Previous s.16 Applications covering the Application Site

Government Departments' General Comments

The application no. to which the comment relates: A/YL-PH/956

眾村民 反對規劃許可申請 A/YL-PH/956 [附圖]

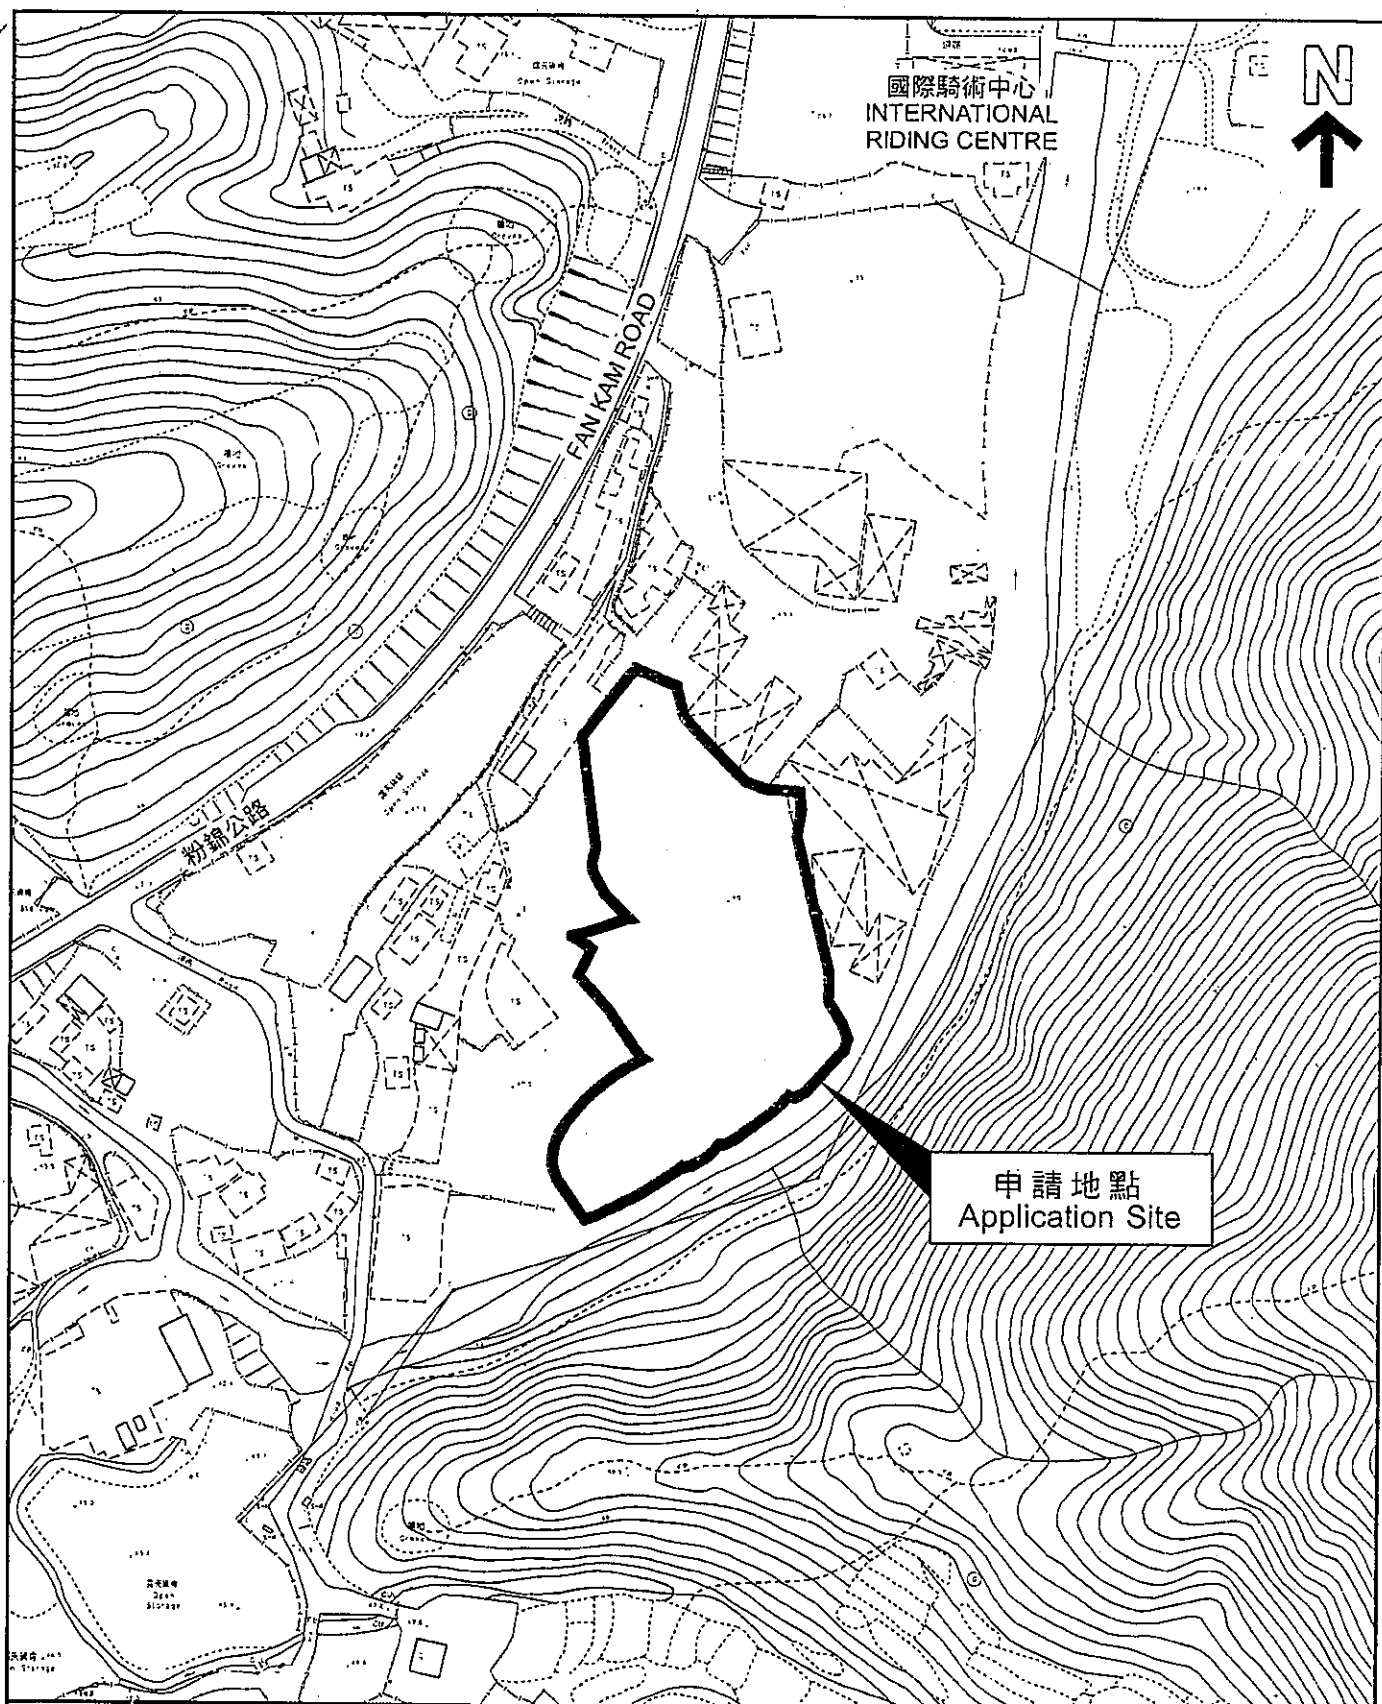
鄉村通道 難 負荷 + 污染

1. 廢鐵、廢膠、廢料回收，引來很多 中大型 貨車 天天出入，傾倒廢料後，便是收錢，司機立即連車 走人。除了製造大量塵埃 粉沫(傾倒過程中)，比騎術學員 肺吸塵埃，亦因現場要用 重型產車將廢料撥埋一堆，實際操作上 產生很大的噪音 及 塵埃，這便是目前 源豐五金 廢鐵回收(在騎術中心對面) 所制造的日常滋擾，且太多架次貨車 出入粉錦公路，對村民 構成危險。其次，要清洗膠樽，碎膠粒 過程中 會產生污水，壓迫廢鐵過程產生塵埃 鐵鏽 + 噪音。

3. 這些廢料回收場，最喜歡在 5:00 P.M. 後 及 星期六 及 星期日 環保署職員放工後，便焚燒 無回收價值的物料，特別是焚燒電線 將塑膠剔除，以獲取紅銅，即將 混在金鑄中的 紙品及塑膠，以高溫焚燒的方法，將紙品及塑膠剔除出去，即燒剩金鑄支架以作賣廢鐵之用。這方法，既節省人手金錢，又高效律，但卻令住在傍邊的村民 叫苦連天。無可能叫環保署職員 唔放工/唔放假，留在現場餵蚊。

4. 焚燒紙品及塑膠(無用的，難篩選的)，產生有毒的氣體，污染空氣。這些打住回收廢料的企業，實在是對目前鄉郊環境 進行破壞。源豐五金 現在正是 做緊這些高污染的動作。美其名 就叫 回收廢料，其實是換湯 不換藥，污染問題無解決到。再加多 一間企業，問題就更惡劣。現在不是用作 舊衣 迷你倉。

5. 回收廢膠，一定要加水，將廢膠 打碎成膠粒，這些產生了的污水，最終 便是流入 雙魚河，污染河道。目前的河道已經 好臭，不要再加把勁。

6. 此申請 A/YL-PH/956，在傍邊，便是露天休閒設施(騎術學校的跑道)是非常 非常 之近，此廢料回收 規劃申請 A/YL-PH/956 是高污染項目，決不可

以 讓它在該地點成長，因與旁邊目前的用途互相衝擊，互有抵觸，更不應 讓 環境進一步惡化。

雨水排放建議圖

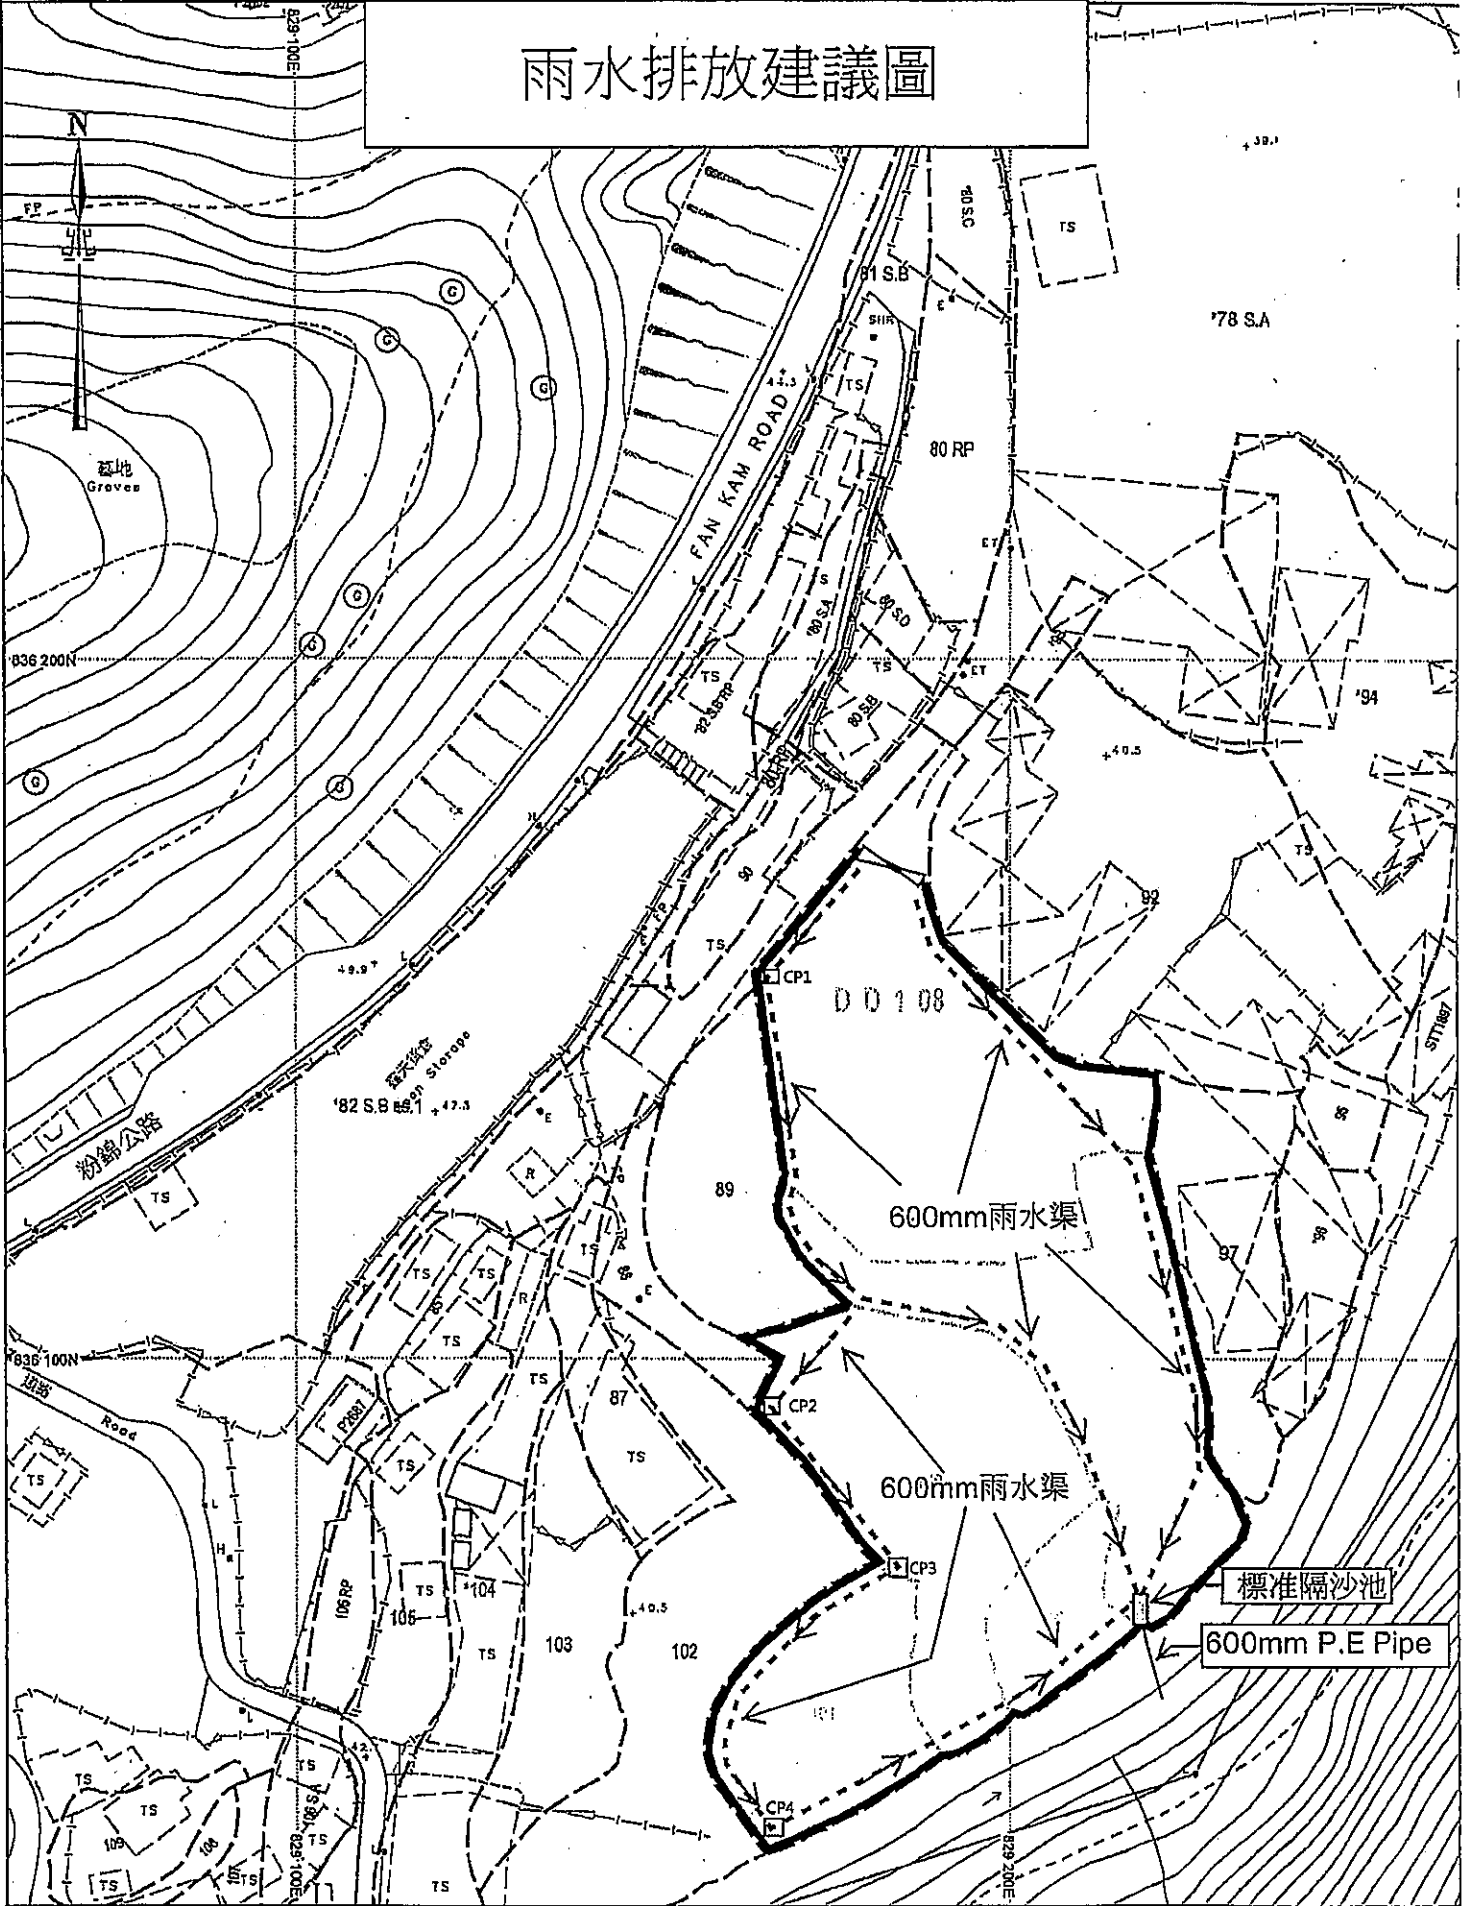
The submitted drainage proposal does not include essential information such as cross sections, catchpit details, u-channel gradient, hydraulic calculations with catchment plan to justify the proposed drainage facilities, etc. Please review the drainage proposal accordingly.

Proposed Fire Service

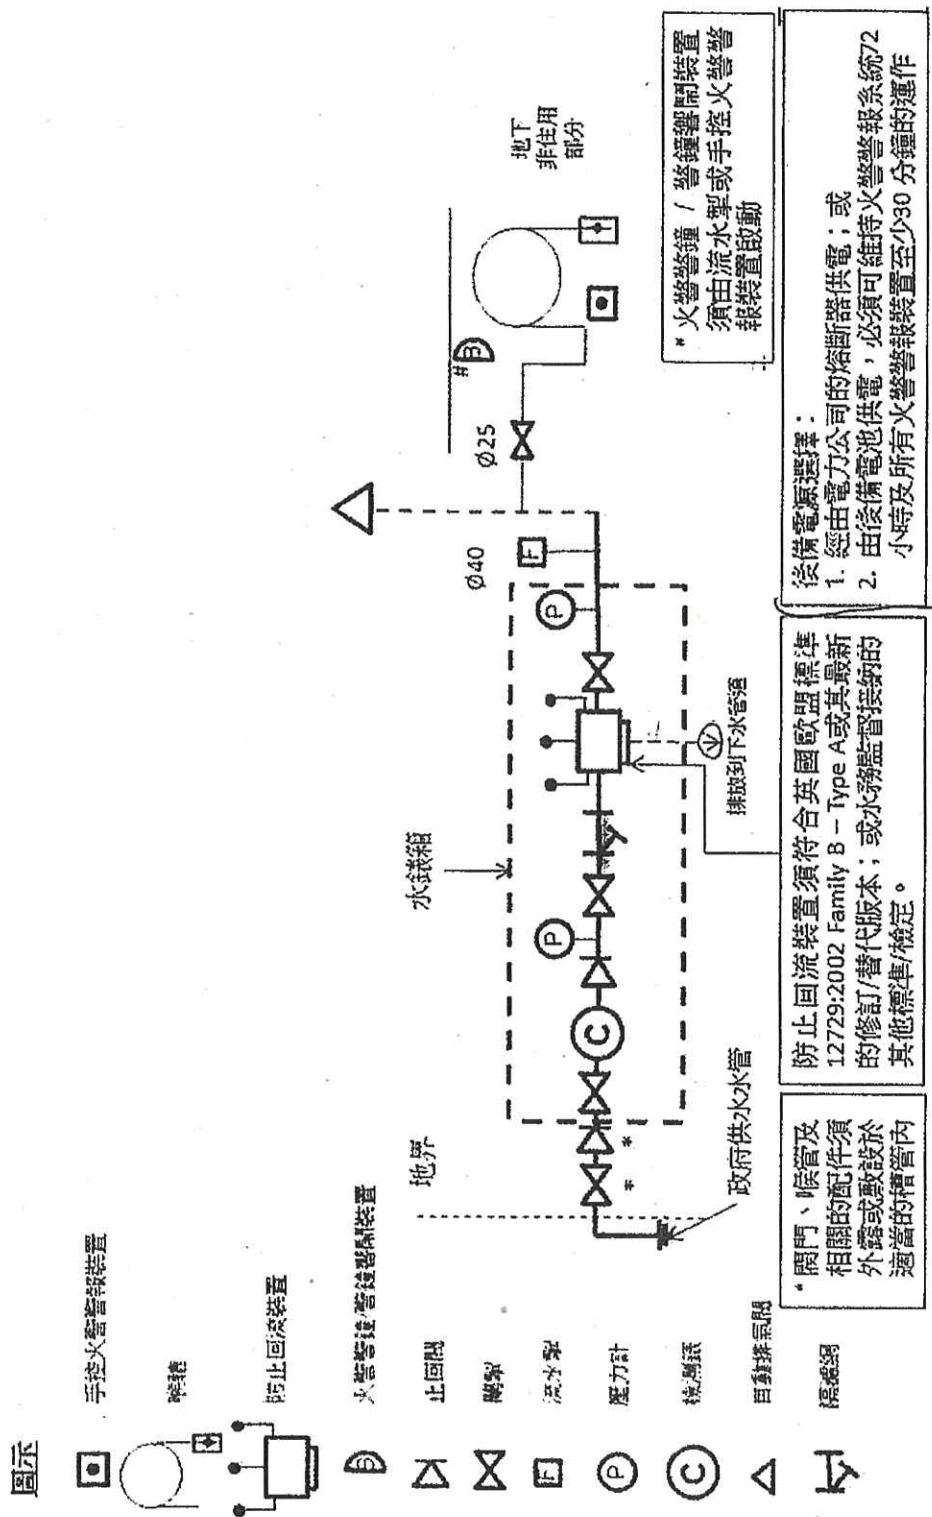
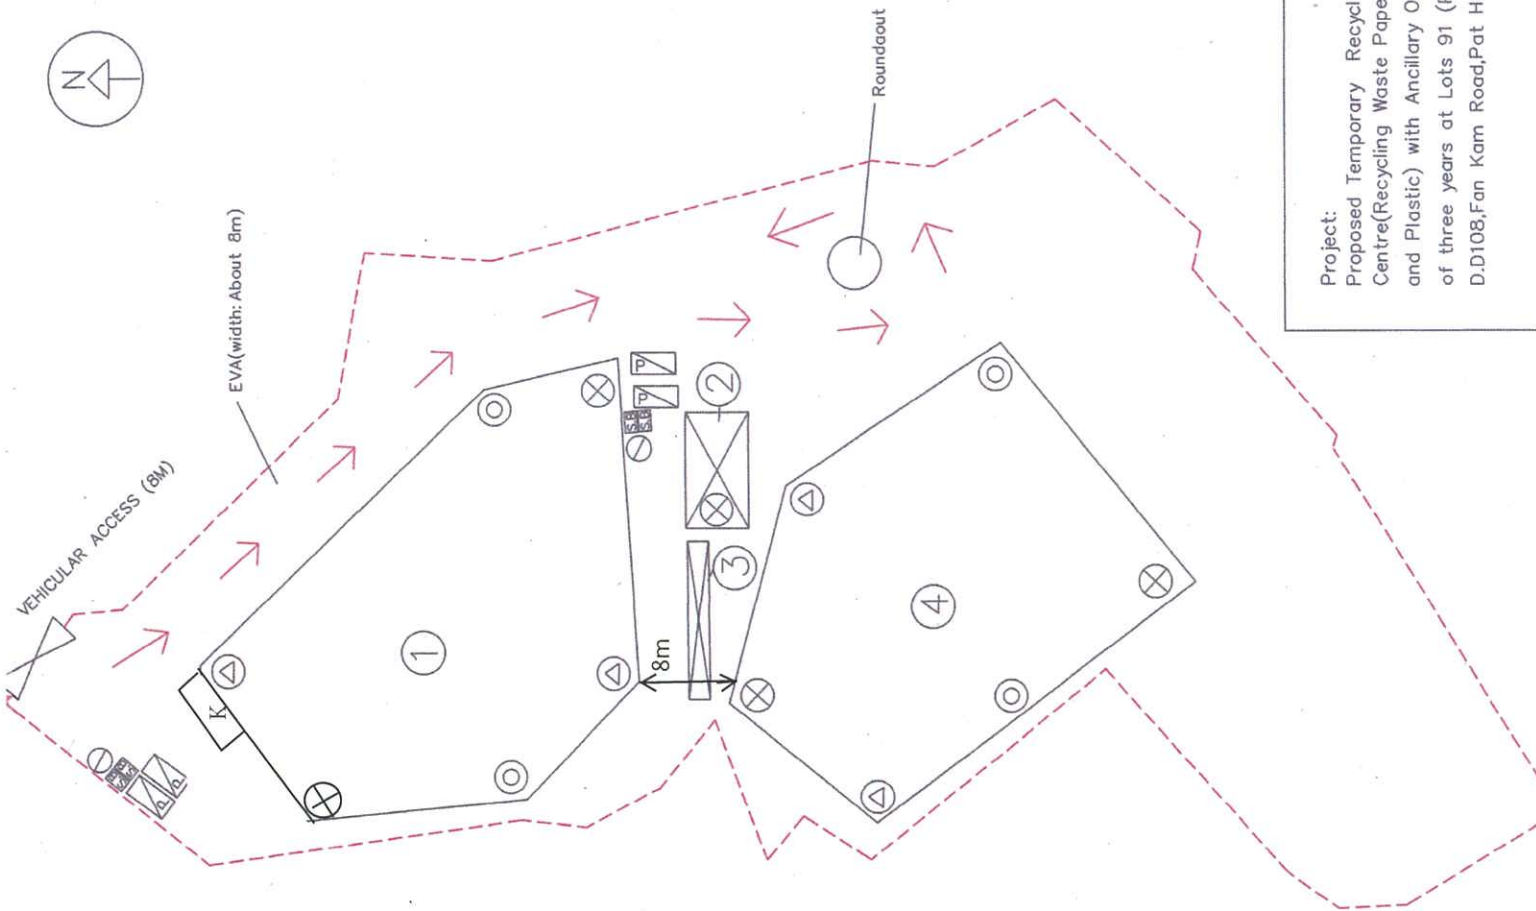
i. A modified hose reel system supplied by a 2m³ FS water tank shall be provided to Structures 1 and

hose reel shall be clearly marked on plans;

vi. The separation distance between each structure shall be clearly marked on plan.
